SUBJECT: Transmittal of Responses to AP1000 DSER Open Items

Draft Safety Evaluation Report Open Item Response

In RAI 251.005, the staff requested that the applicant provide values of crack morphology parameters, e.g., surface roughness, number of 45 degree and 90 degree turns, etc., that were used in generating the BACs for LBB. The NRC staff also asked for a comparative study, using the values of crack morphology parameters associated with transgranular stress corrosion cracking (TGSCC). This information and the study were requested to evaluate the BACs and to understand the sensitivity of the AP1000 LBB analyses to a crack morphology similar to PWSCC. In its response to RAI 251.005, the applicant provided the values of crack morphology parameters used in generating the BACs. However, since chlorides will be controlled at minimum levels in the AP1000 LBB candidate piping systems water environment and the hydrogen overpressure will keep the oxygen levels to near zero, the applicant discounted the possibility of TGSCC and considered the comparative study using the crack morphology parameters associated with TGSCC not necessary. The applicant's argument does not address the intent

Figure 39 : Bounding Seismic Increase Factors
Seismic Response Spectra, Steam Generator Support Elev. 153' (East-West) – 4th Stage ADS

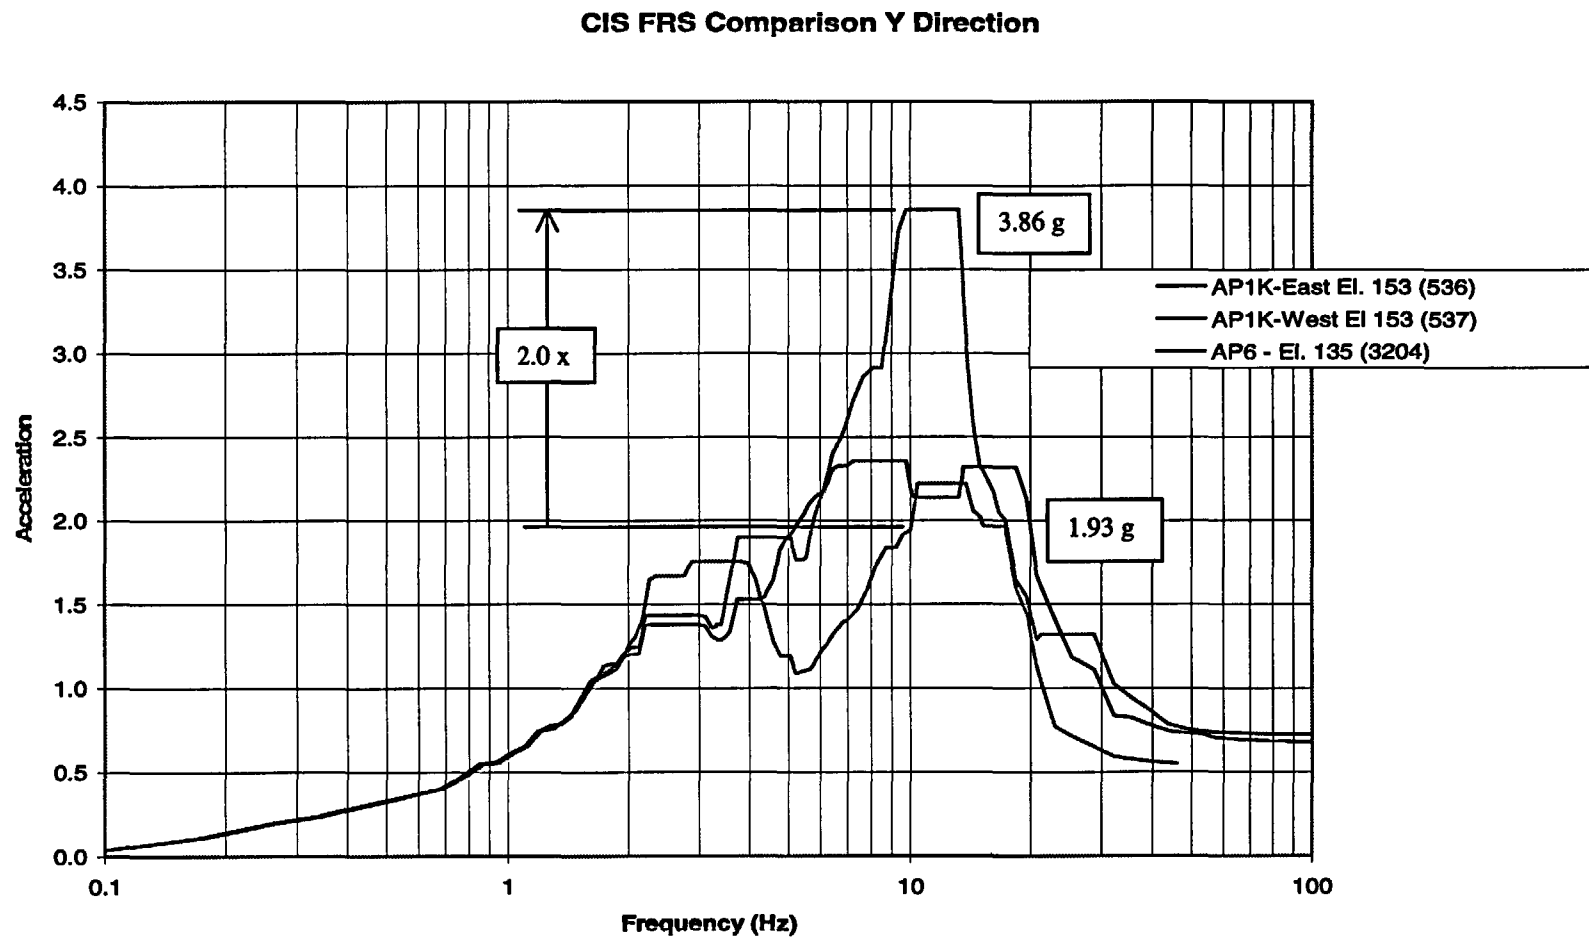
The ADS Stage 4 pipe diameter is larger than the AP600 (12"). Per Figure 39, the seismic increase factor is 2.0 based on the seismic response spectra at approximately 10 Hz. The maximum stress is 23.7 ksi accounting for both the seismic increase factor and the increase in pipe diameter. The adjusted stress is less than the BAC stress of 40.7 ksi. Figure 40 shows the BAC and the estimated stresses for the AP1000 plant. Feasibility of LBB for AP1000 is confirmed.

The ADS Stage 4 pipe diameter is larger than the AP600 (10"). Per Figure 39, the seismic increase factor is 2.0 based on the seismic response spectra at approximately 10 Hz. The maximum stress is 30.0 ksi accounting for both the seismic increase factor and the increase in pipe diameter. The adjusted stress is less than the BAC stress of 31.6 ksi. Figure 41 shows the BAC and the estimated stresses for the AP1000 plant. Feasibility of LBB for AP1000 is confirmed.

The ADS Stage 4 pipe diameter is larger than the AP600 (10"). Per Figure 39, the seismic increase factor is 2.0 based on the seismic response spectra at approximately 10 Hz. The maximum stress is 26.4 ksi accounting for both the seismic increase factor and the increase in pipe diameter. The adjusted stress is less than the BAC stress of 51.9 ksi. Figure 41 shows the BAC and the estimated stresses for the AP1000 plant. Feasibility of LBB for AP1000 is confirmed.

Figure 1: Cold Water Droplet Size Sensitivity

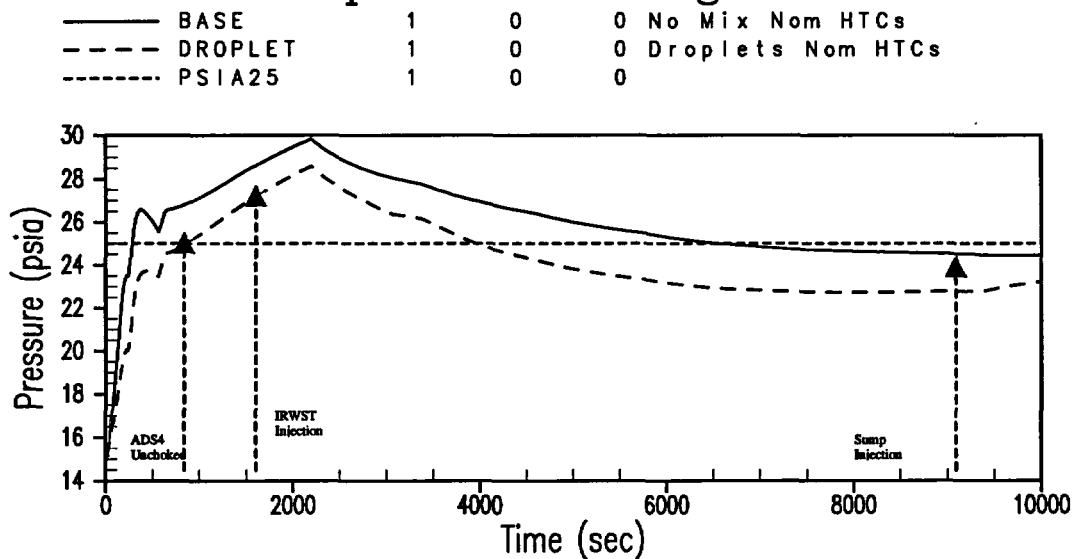
Figure 1 shows the containment pressure response for the two cases. By allowing the cold water to interact with the steam and two-phase mixture in the compartment vapor space, the overall pressure is reduced by approximately 2 psi. The pressure remains above 25 psia between the time that the ADS4 flow becomes non-critical and the time of IRWST injection. The interaction between the steam and the water droplets in the compartment causes steam to condense resulting in less steam to pressurize the containment. In addition, the water droplets are heated so that the water accumulating on the compartment floor is saturated.

Figure 2: Heat Transfer Multiplier Sensitivity

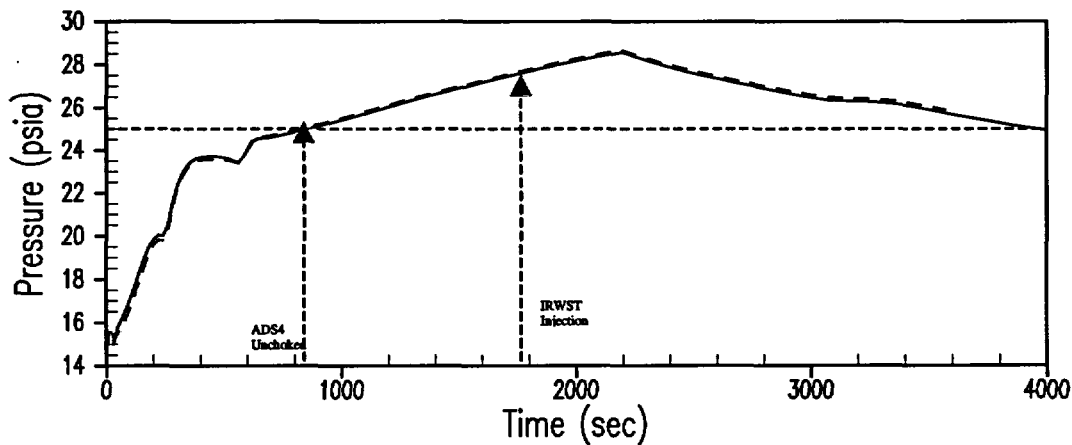
As a sensitivity, the multiplier on the Uchida correlation was increased to 4.0 during the blowdown period (<500 seconds). Figure 2 shows the containment pressure response with and without this multiplier assuming mixing of the cold water spill as described above. These results show little sensitivity to the increased heat transfer coefficient.

Figure 28-3

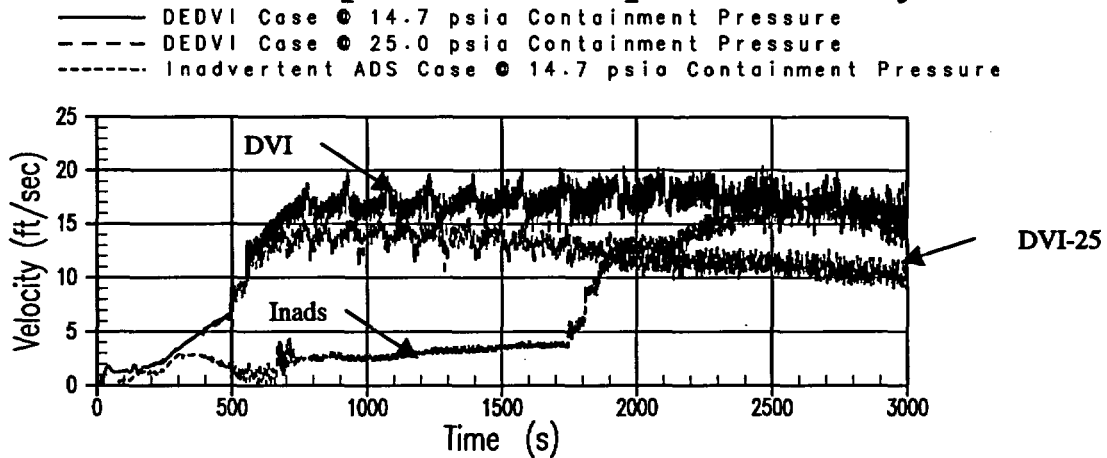
Figure 28-3 shows the NOTRUMP calculated core exit vapor velocity for the AP1000 DEDVI event at two containment pressures (25 psia and 14.7 psia) and for the Inadvertent ADS 1-3 event at 14.7 psia containment pressure. The vapor velocity is higher for the DEDVI case at 14.7 psia than for the Inadvertent ADS 1-3 at 14.7 psia. Since the 14.7 psia containment pressure applies in the APEX-1000 test facility, this is another indication that the DEDVI tests performed in APEX-1000 are somewhat more limiting from the viewpoint of vapor velocity and its effects on entrainment and ADS4 venting.
